# 50 MONROE STREET ELEVATOR MODERNIZATION

City of Rockville  
APPROVED  
2022-1072-ALT

DELTA PROJECT NO. 2019.331.003  
FEBRUARY 16, 2022  
100% SUBMISSION

**SEE FIRE MARSHAL  
REVIEW COMMENTS**

Drawing Title  
ENLARGED SECTIONS

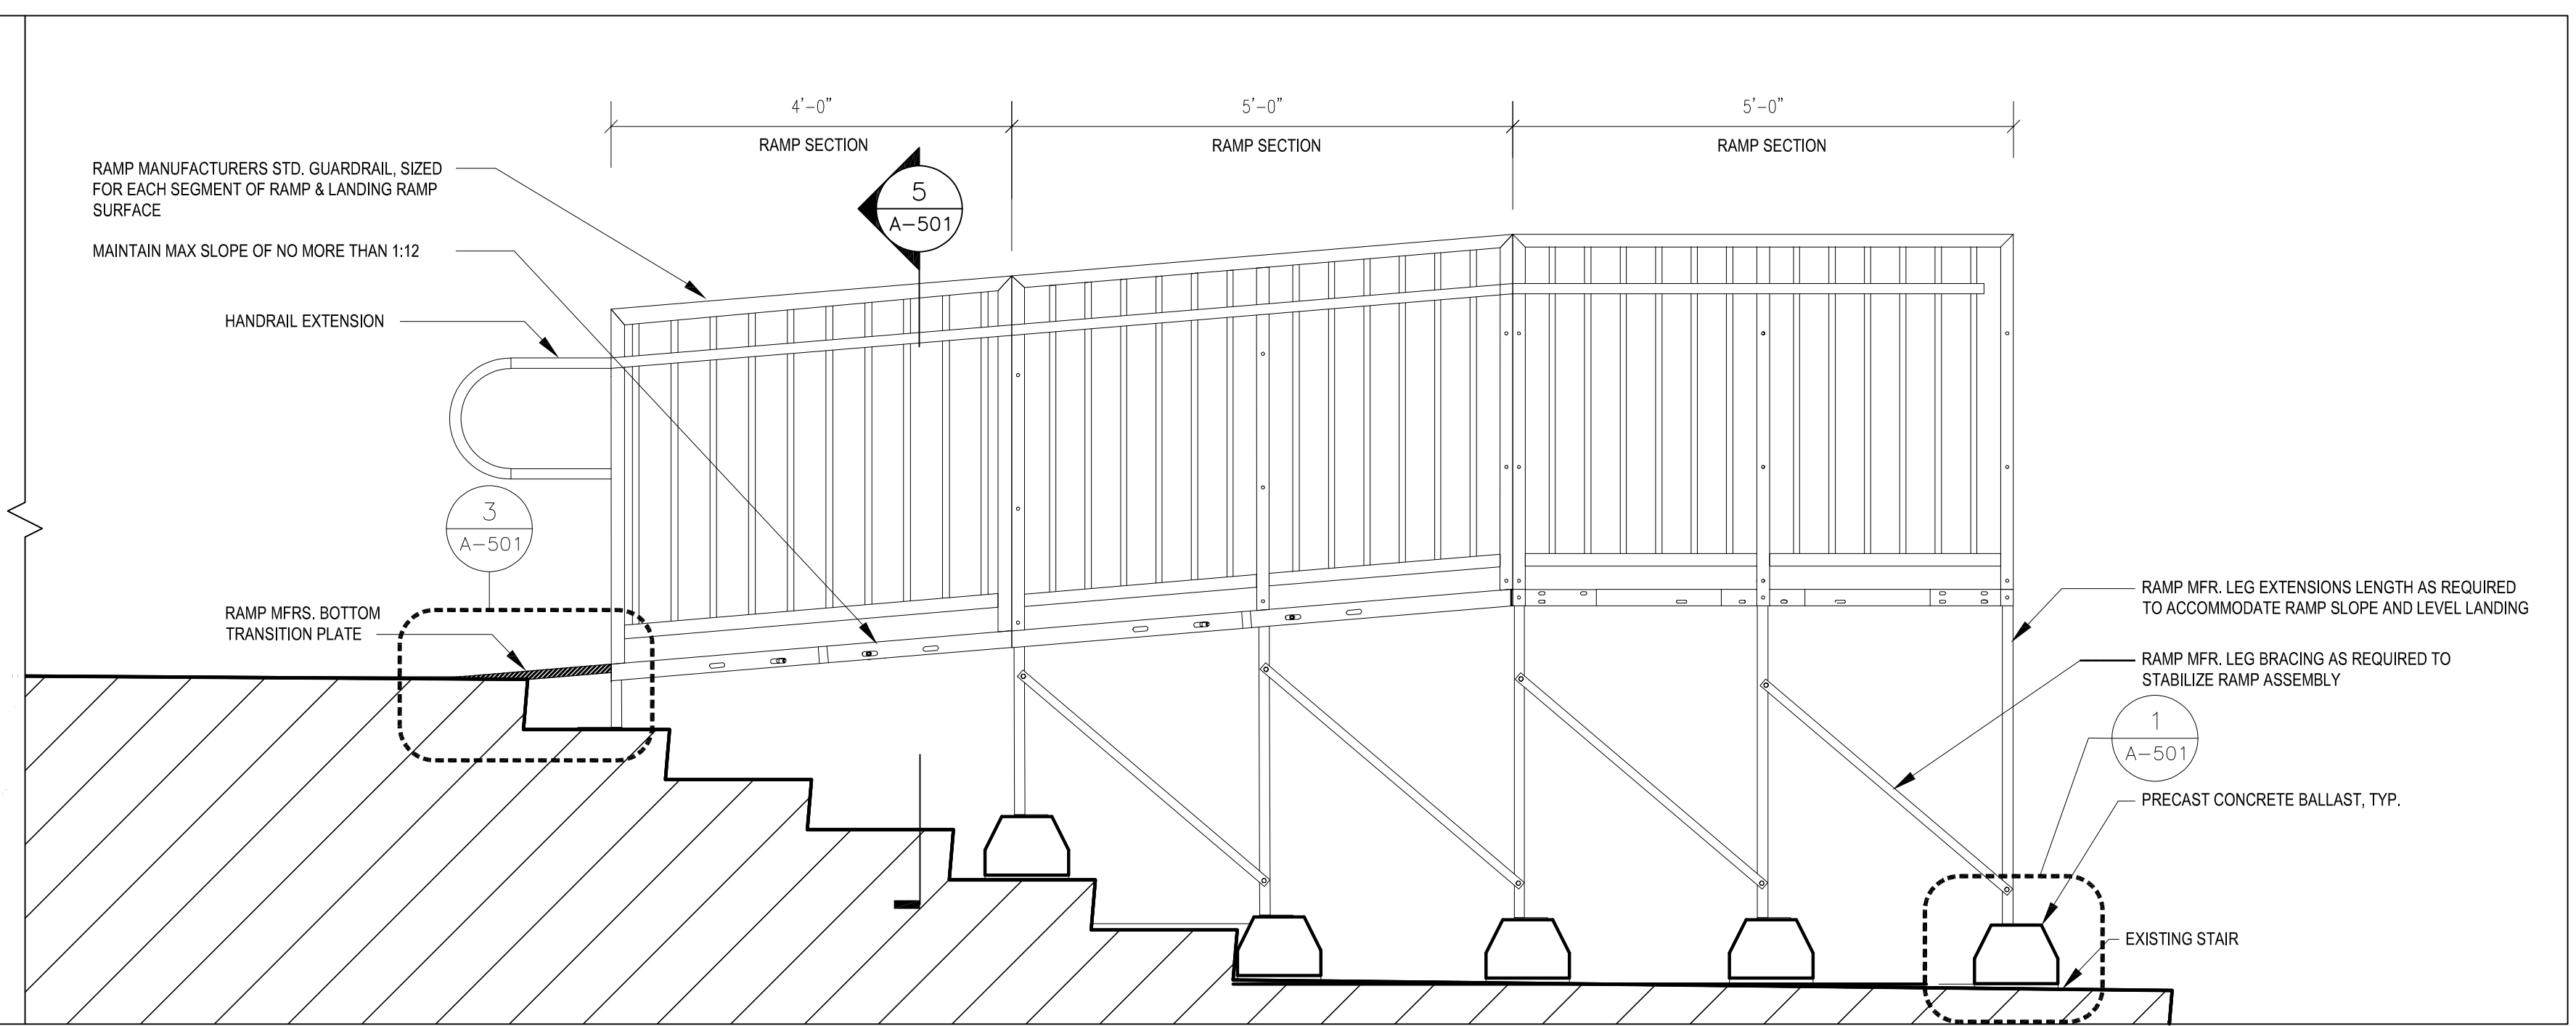
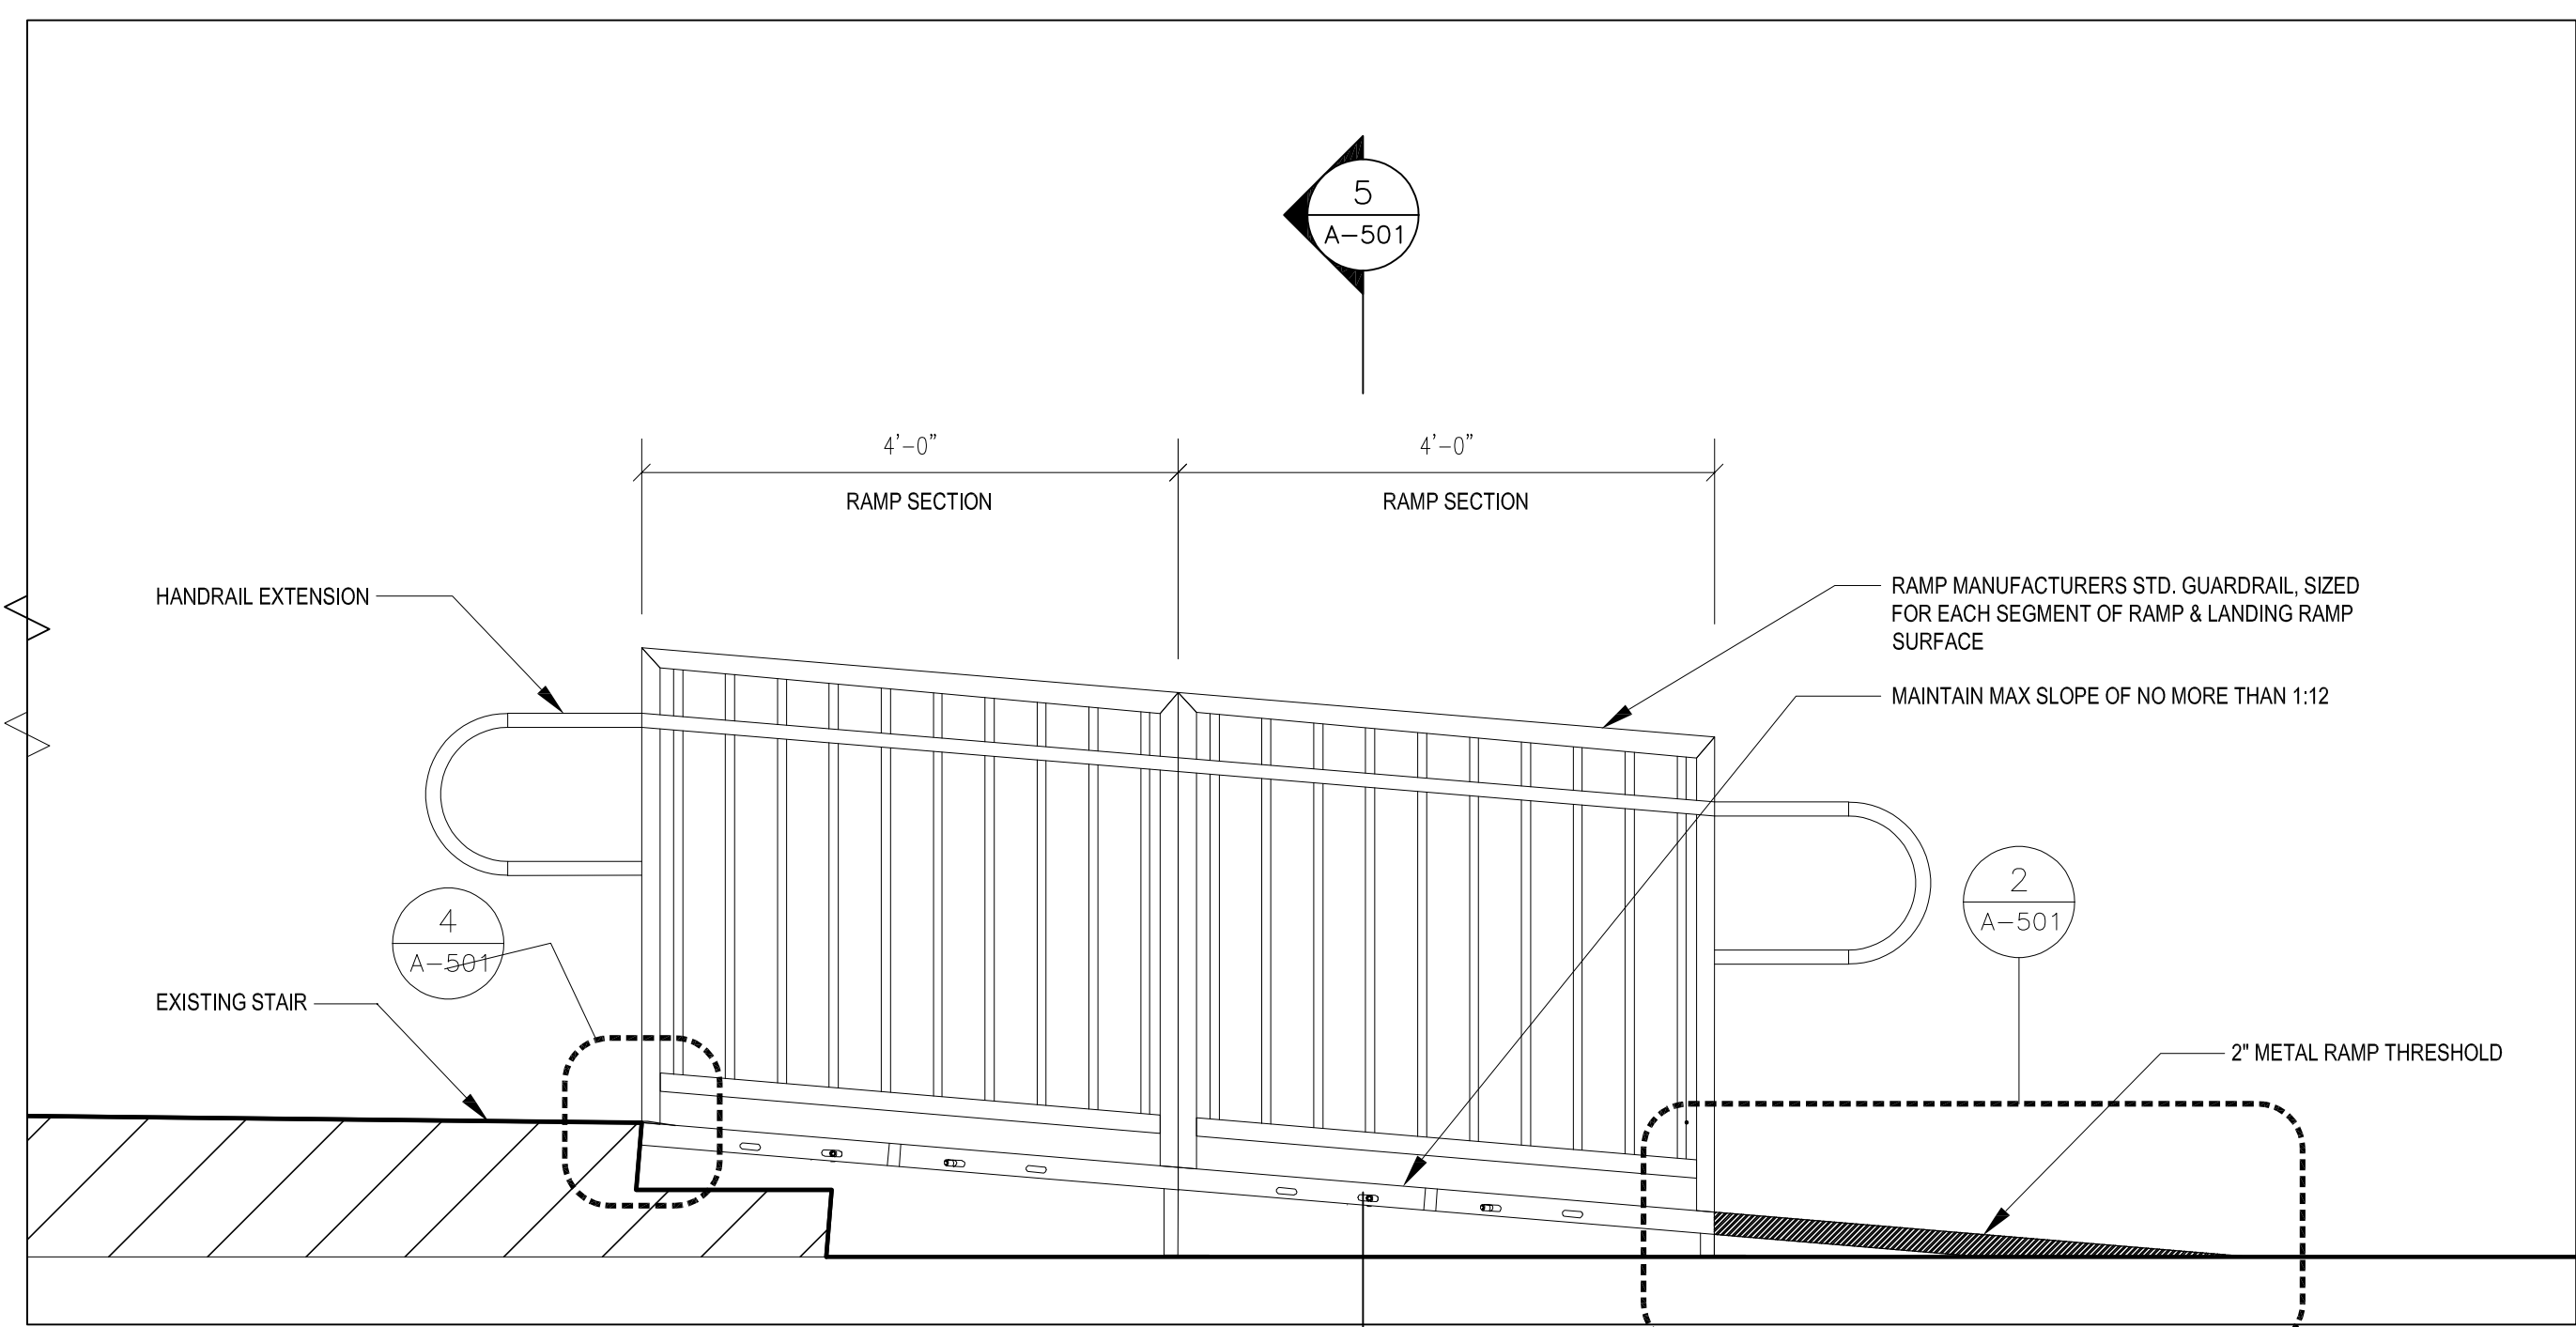
**SEE FIRE MARSHAL PLAN  
REVIEW COMMENTS ON  
Cover sheet**
